- Espar Heater Fuel Pickup Tube Solder Joint Failure
- After change from brass to steel fitting
- Espar heater fails to run, tube falls into fuel tank

- FSPR 38779
- FRACAS 13951

Solder Joint Fails Tube Falls in Fuel Tank

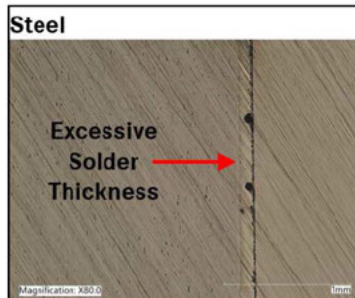
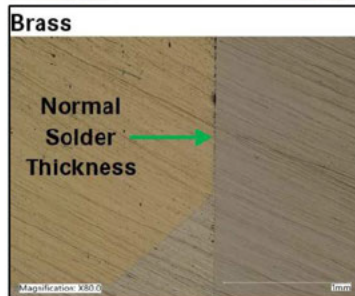
- Eng'g was directed by DDC to remove all brass from fuel system
- New steel version ended up with excessively large solder joint gap which made the joint very weak
- Solder joint fails and tube falls out of fitting and into fuel tank
- Driver only notices when attempting to start heater and it doesn't (no fuel)

- Changed back to original brass design via Deviation
- 03/15/2024

- Resolving issue with a revised pickup tube design
- Nickel plated brass was chosen
- Will be a Campaign
- Pushing for new design production changeover by 07/31/24
